Rambler Split Level

The following items are conditions for permit issuance and strict compliance is mandatory.

VAULTED END WALL DETAIL

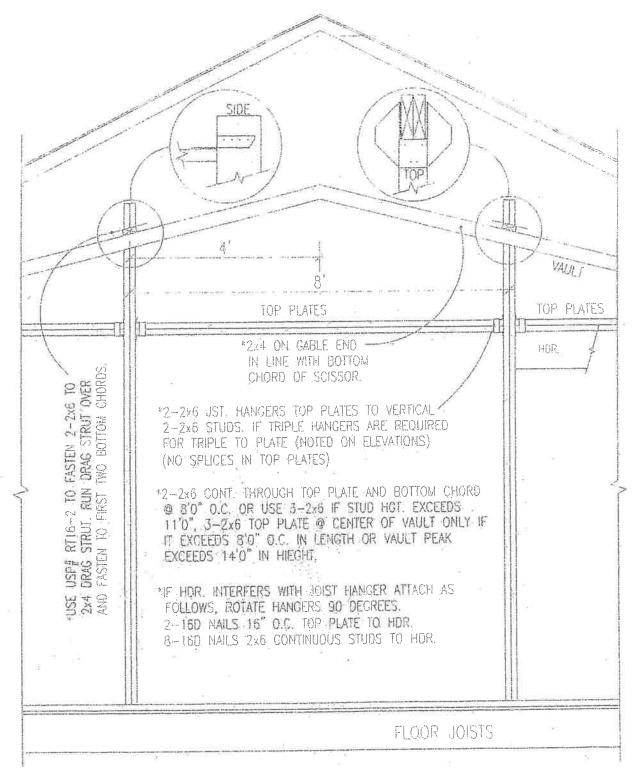
- 16. Vault walls shall be balloon framed or have King posts installed in them. (see attached)
- Wall section on the front of the garage less than 2'-8" wide shall be braced wall panels.(see attached) MSBC1309/R602.10
